Refer to: HSA-10/B47B

**In a joint letter dated June 29, you and Ms. Mary Lou Ralls, Director of TxDOT's Bridge Division, requested Federal Highway Administration acceptance of a modified guardrail to bridge rail transition design. A copy of this response is being sent directly to Ms. Ralls.**

File: B-47 (MOD-ITRAN)

<b>MwRSF</b> University of Nebraska C.E. Department	
<b>ITRANS (Vertical Wall)</b>	
DATE: 5/27/99	
SCALE: none	
DRN: FAK	vwall04

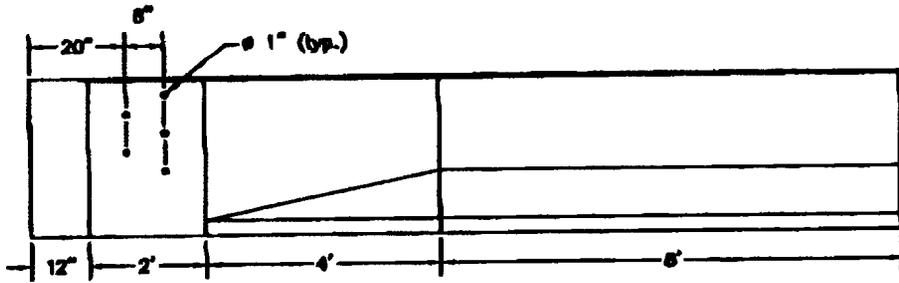
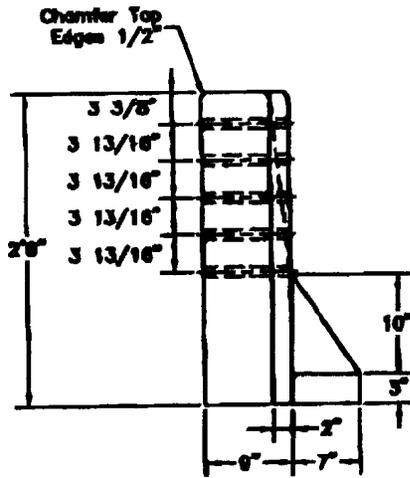
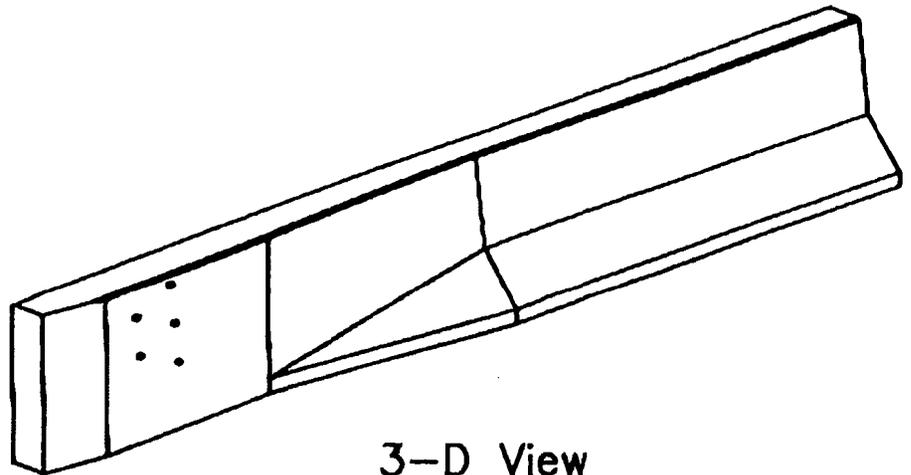
In your March 12, 1999, letter to Mr. Richard Powers of my staff, you asked if a modification to two previously-accepted guardrail-to-bridge rail transition designs would be considered acceptable by the Federal Highway Administration (FHWA) without additional testing. Specifically, the modification consisted of attaching either one of the nested Thrie-beam designs accepted in my March 6, 1998, letter to Mr. Ron Faller of your staff directly to a vertical concrete parapet. The earlier designs incorporated a fabricated steel connector plate to allow a direct vertical-plane connection to a safety shaped parapet.

Our conditional acceptance is based on all other design aspects of the transitions remaining the same as noted in our March 6, 1998, acceptance letter, including the 100-mm high curb which we believe is needed to minimize the likelihood of wheel snagging on the end of the concrete wall. The enclosure shows the dimensions and reinforcing details of your modified design.

We have reviewed your proposal and noted that a Thrie-beam transition to a vertical concrete wall was the first priority of the State highway representatives participating in the FHWA-sponsored pooled fund study No. 2-134, "Testing of New Bridge Rail and Transition Designs." Since we believe your proposed modification will perform as well as the two accepted designs, and will be verified when testing is completed under the aforementioned pooled fund effort, we will consider your modification to be *conditionally* acceptable as a test level 3 transition pending successful completion of the anticipated pooled fund test(s). If any changes to your design are deemed necessary based on the outcome of our tests, we will notify you accordingly.
